## QUALITY ASSURANCE -- NON-CONFORMANCE REPORT

**Report No:** NCR-000127

**NCR #:** ZPMC-0121

**Reference Description:** ABF-SUB-000634R01, "Repair Procedure for Closed-Rib Welds"

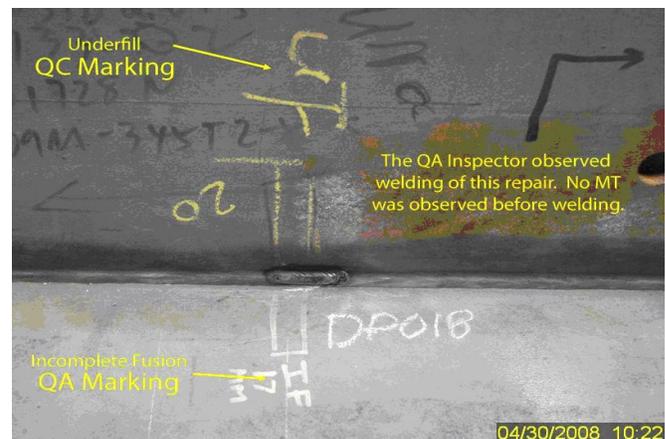
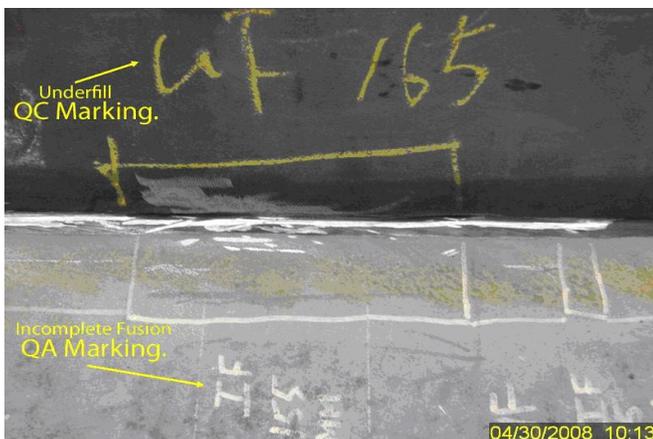
The Contractor did not perform weld repairs in accordance with accepted procedures. The Contractor performed repairs to lack of fusion in a closed rib weld without performing MT after grinding to ensure the removal of all defects. When informed of this, the Contractor stated that the repair was being performed for underfill, not for lack of fusion. The accepted closed rib weld repair procedures do not allow grinding prior to welding for underfill repair. This occurred on weld joint #008 of deck panel DP-021-002.

It was also observed that the Contractor has performed grinding in preparation for weld repairs on other defects which the Contractor has classified as underfill. This was observed in weld #007 of deck panel DP-018-002.

**Reference Resolution:** ZPMC will check surface condition and mark defect by specification code and will consider the view of ABF and CT when correcting defects.

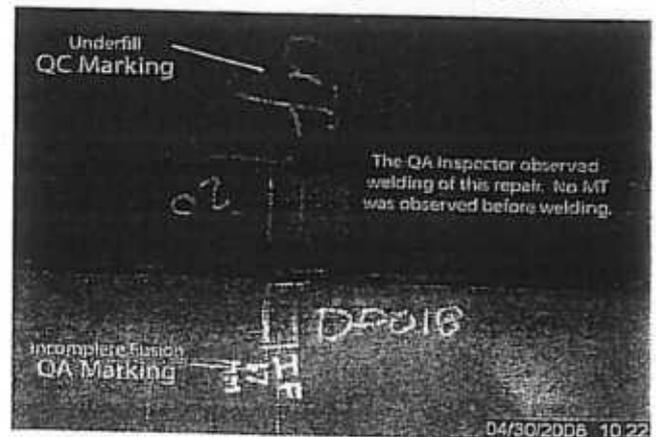
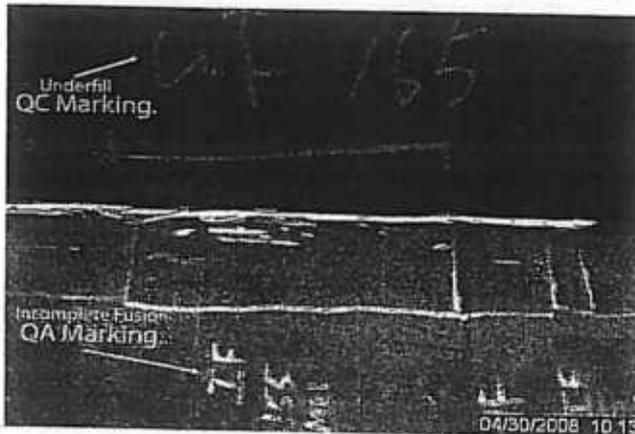
The Contractor did not perform weld repairs in accordance with accepted procedures. The Contractor performed repairs to lack of fusion in a closed rib weld without performing MT after grinding to ensure the removal of all defects. When informed of this, the Contractor stated that the repair was being performed for underfill, not for lack of fusion. The accepted closed rib weld repair procedures do not allow grinding prior to welding for underfill repair. This occurred on weld joint #008 of deck panel DP-021-002. It was also observed that the Contractor has performed grinding in preparation for weld repairs on other defects which the Contractor has classified as underfill. This was observed in weld #007 of deck panel DP-018-002.

DP-018-002 was repaired and inspected by gate to gate UT and PAUT. The repair was accepted as indicated by NDT. The panel is accepted with an ABF Green Tag.
